PHILCO RADIO & TELEVISION CORP.

MODEL 90, 90-A
(With 2-47s)
Schematic
Changes

PHILCO MODEL 90

Serial Nos. B-32001 to B-35000
and above B-53100

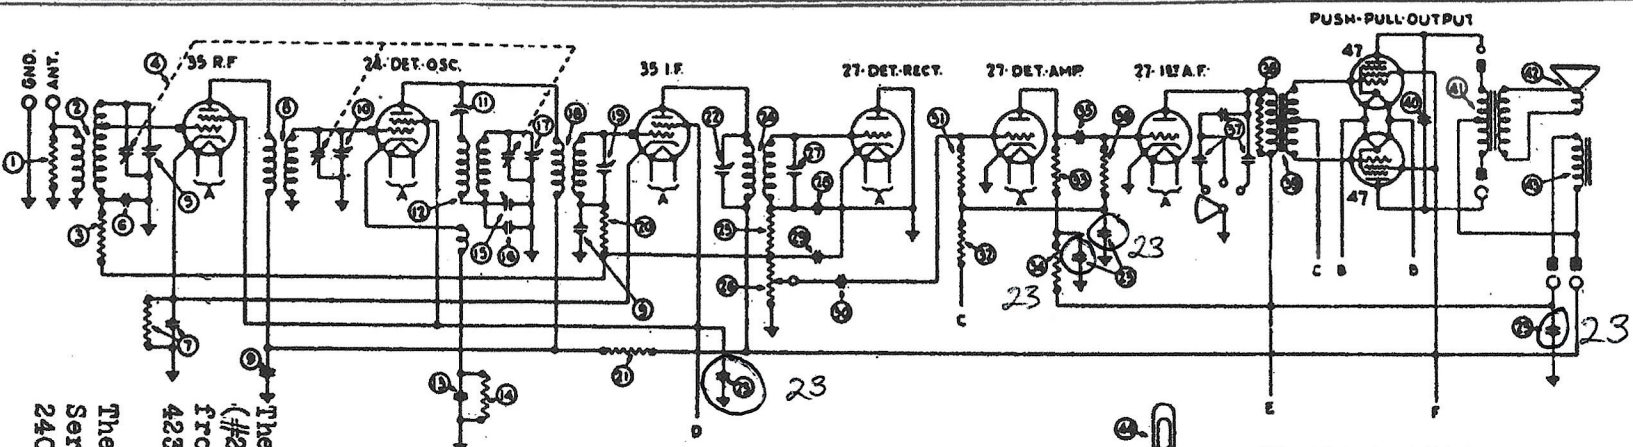
Attention is called to the fact that the speakers for the new Model 90 (serial nos. B-32001 to B-35,000 and above B-53,100) are not interchangeable with the speakers for the earlier Model 90 with the single pentode output tube. This is due to the fact that the output transformers are different. Part 2635 output transformer is required for the models with push pull pentode output tubes and part 2673 is required for the models with the single pentode output.

The plate filter resistor of the last 27 tube (#27 in Service Bulletin No. 85) has been changed from 25,000 ohms, part 3656, to 51,000 ohms, part 4237.

The grid coupling resistor of the 47 tube (#29, in Service Bulletin No. 85) has been changed from 240,000 ohms, part 4410, to 99,000 ohms, part 4411.

The grid filter resistor for the last 27 and the 47 tubes (#51, in Service Bulletin No. 85) has been changed from 240,000 ohms, part 3768, to 490,000

SPEAKER PLUG AND SOCKET CONNECTIONS SHOWN

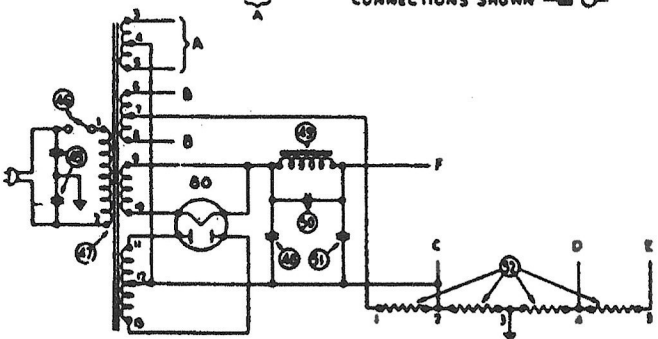
New Speaker in Model 90
